TECHNICAL ORDER  
NO. 01-100LAA-22

30 March 1950

INSTALLATION OF EMERGENCY CANOPY RELEASE - L-17A (RYAN)

Figure 1

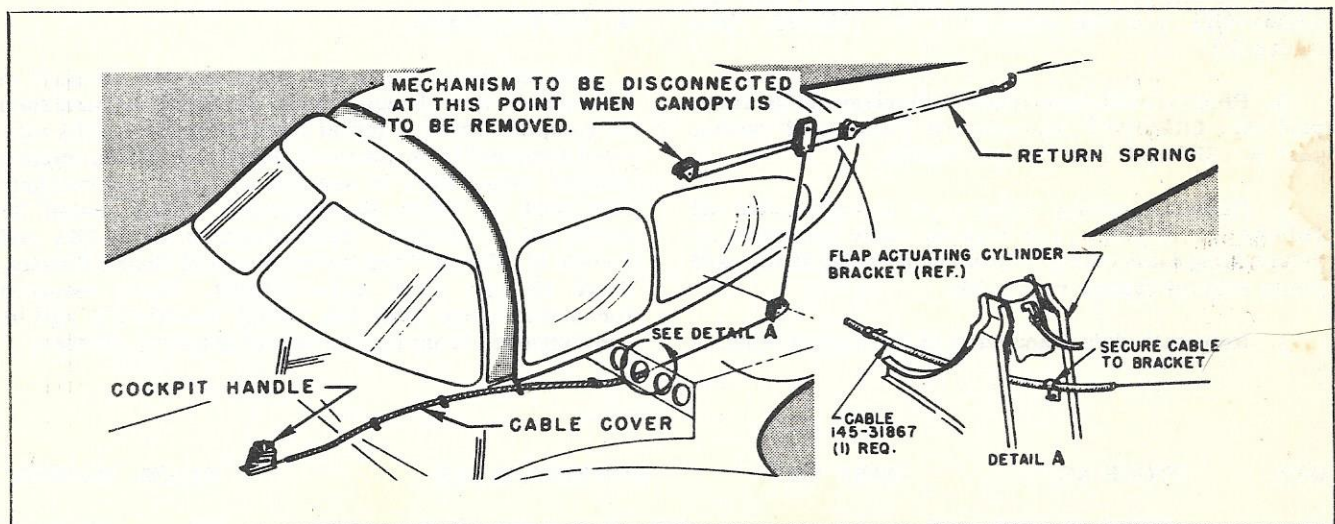
c. Install new assist cable assembly, part No. 145-31867, rerouting as shown in figure 1. Reinstall center

Figure 2

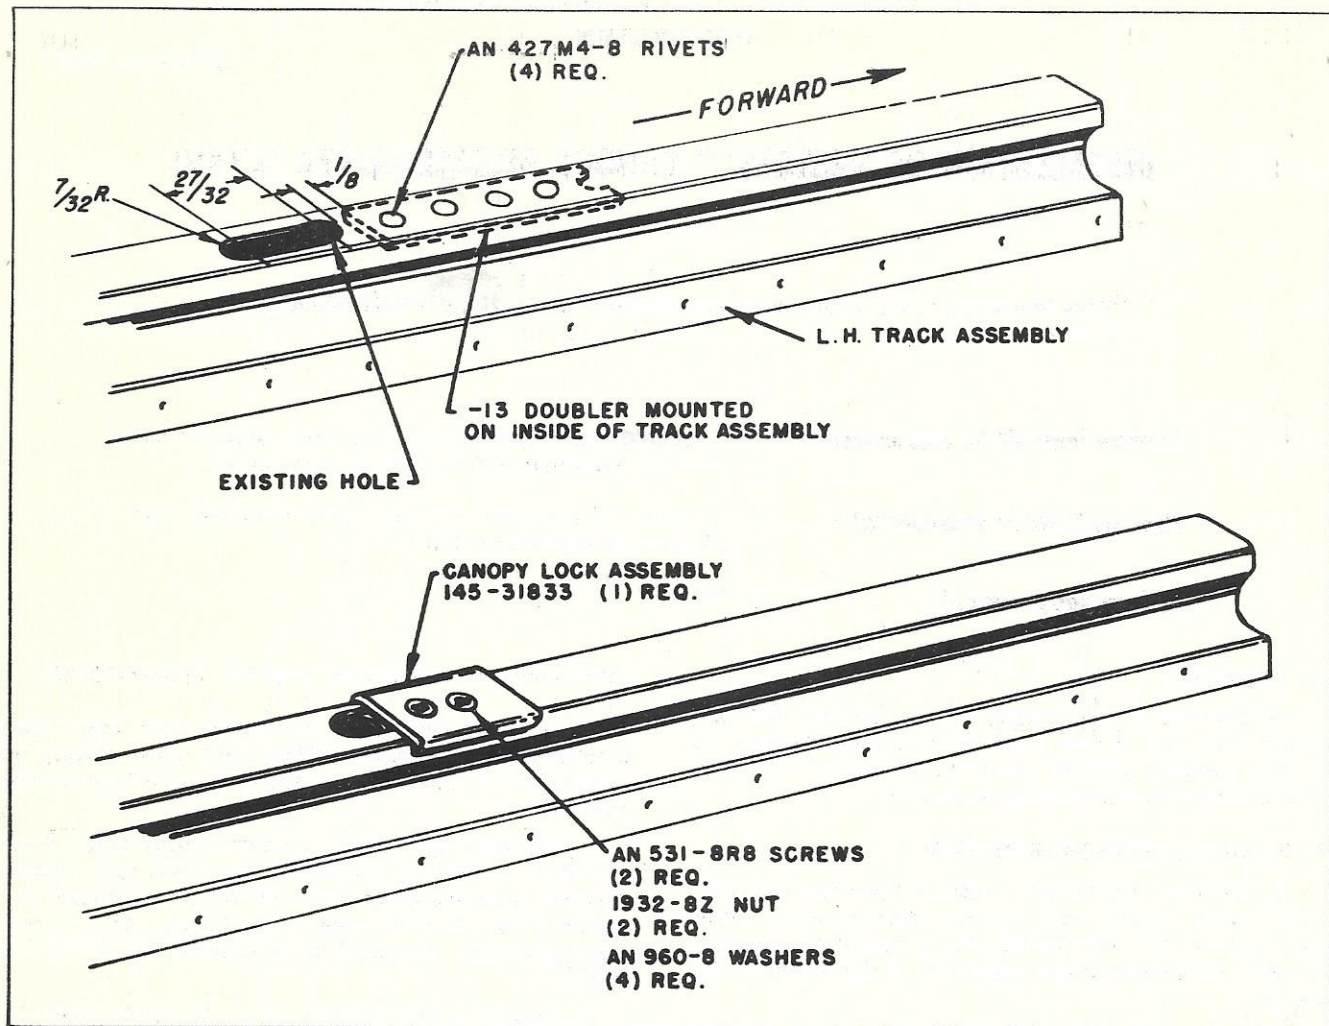
f. Install track doubler, part No. 145-31829-13. Locate doubler 1/8 inch forward of edge of existing hole in track. Use four each rivets, part No. AN427M4-8, equally spaced. Cut slot in track, as shown in figure 2.

g. Install canopy lock assembly, part No. 145-31833, on left-hand track using two screws, part No. AN531-8R8, and two nuts, part No. 1932-8Z. (See figure 2.)
